Revised Timing Belt Tensioner

2002-2003 Acura 3.2L SOHC Engines
A revised timing belt tensioner for 2002-2003 Acura 3.2L engines is part of a product improvement by Acura.

Cylinder Head Gasket Leak On 1988-95 1.6L Honda Civic Engines

Figure 2 Torque sequence for 1988-'95 1.6L Honda Civics (non-VTEC). Oil leaks and coolant loss may be eliminated by using an MLS head gasket.

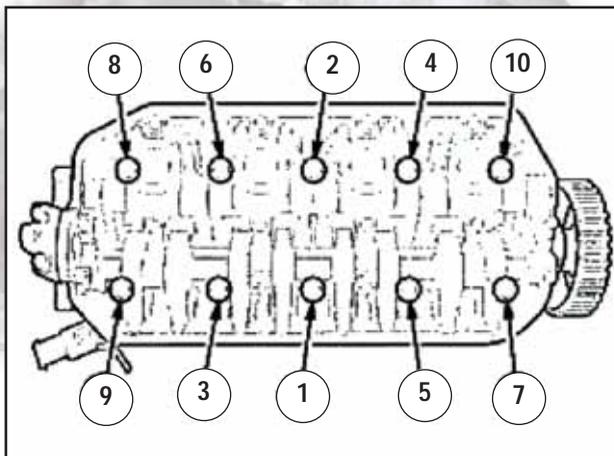
You or your supplier customers may have received complaints that oil is leaking externally or there is coolant loss on 1988-'95 1.6L Honda Civic engines due to a cylinder head gasket leak. This information does not apply to the VTEC engines.

This information also supersedes Honda service bulletin 97-047, dated September 29, 1997. The current corrective action prescribed by Honda involves installing a new MLS cylinder head gasket (p/n 12251-P01-004) and 10 new head bolts (p/n 90005-PM3-004). It is important to note that the following torque

4) Apply engine oil to the threads and washers of the new cylinder bolts. Install the bolts, and torque them in the sequence and steps shown in **Figure 2**, below. Do not use the head bolt tightening steps in the Honda service manuals.

5) Step 1. Tighten all 10 bolts in sequence to 14 ft.lbs. (20 Nm).

Step 2. Tighten all 10 bolts in sequence to 36 ft.lbs. (49 Nm).

Step 3. Tighten all 10 bolts in sequence to 49 ft.lbs. (67 Nm).

Step 4. Tighten bolts 1 and 2 to 49 ft.lbs. (67 Nm) again.

Figure 3 Hyundai camshafts are etched with a letter on the end for identification.

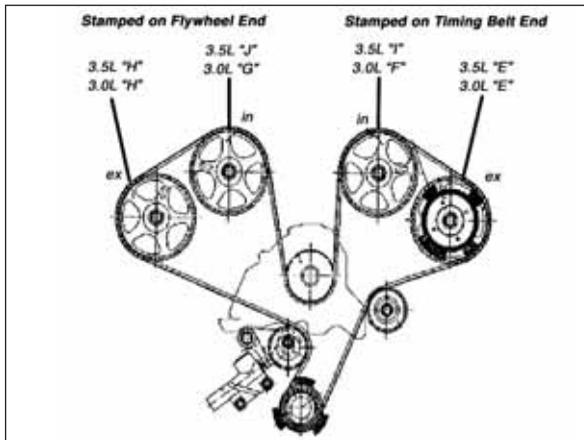
3.5L engines. Previously published service manual information has been called misleading, resulting in incorrect assembly. Each of these engines use four unique camshafts that look the same.

Caution: while the camshafts all have letters cast in between the lobes with RI, RE, LI, LE, these casting letters are meaningless and should NOT be used to determine camshaft location.

Each camshaft for the 3.0L and 3.5L engine is etched with a letter on the end of the camshaft to identify the location the camshaft should be mounted in. The letter should be read while held in the "6 o'clock" position and viewed with a good working flashlight. Use the illustrations in **Figure 3**, above, for identification and location.

Figure 5 Nissan 3.3L intake manifold torque sequence.

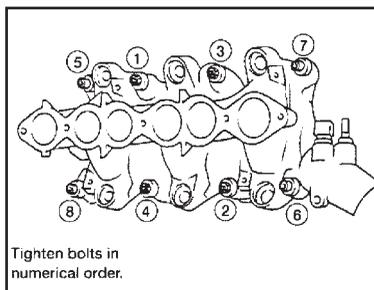
4) Tighten the cylinder head bolts and the intake manifold bolts in 14 steps,

and in the numerical order as shown in **Figure 5**, below. Use the specified angle wrench – ST10120000 (J24239-01) – as necessary.

1) Tighten cylinder head bolts in sequence to 22 ft.lbs. (29 Nm).

2) Tighten cylinder head bolts in sequence to 43 ft.lbs. (59 Nm).

3) Loosen all cylinder head bolts completely.

4) Tighten cylinder head bolts 7 ft.lbs. (10 Nm).

5) Tighten intake manifold bolts and nuts in sequence to 2.9 ft.lbs (4 Nm).

6) Tighten intake manifold bolts and nuts in sequence to 13 ft.lbs. (18 Nm).

7) Tighten intake manifold bolts and nuts in sequence to 12-14 ft.lbs. (16-20 Nm).

8) Loosen all intake manifold bolts and nuts completely in sequence.

9) Tighten cylinder head bolts in sequence to 22 ft.lbs. (29 Nm).

10) Tighten cylinder head bolts in sequence to 60°- 65°degrees (clockwise). If an angle wrench is not available, tighten cylinder head bolts in sequence to 40-47 ft.lbs. (54 - 64 Nm).

11) Tighten cylinder head sub-bolts in sequence to 6.7-8.7 ft.lbs. (9.0 -11.8 Nm).

12) Tighten intake manifold bolts and nuts in sequence to 2.9 ft.lbs. (4 Nm).

13) Tighten intake manifold bolts and nuts in sequence to 6.5 ft.lbs. (9 Nm).

14) Tighten intake manifold bolts and nuts in sequence to 5.8-7 ft.lbs. (8 - 10 Nm).

Figure 4 Install the washers between the bolts and cylinder head with the washer beveled side up on Nissan 3.3L engine.

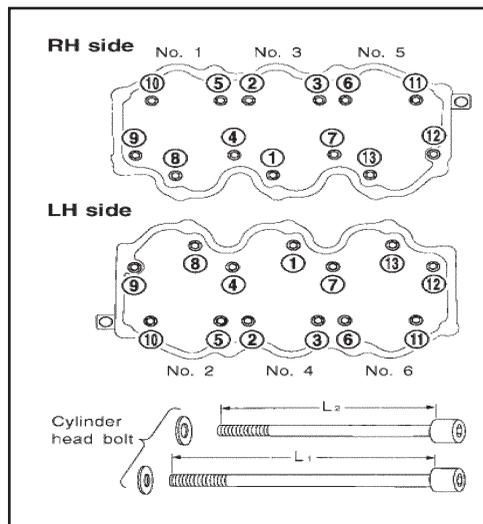
2) Install the washers between the bolts and cylinder head with the washer beveled side up as shown in **Figure 4**, right.
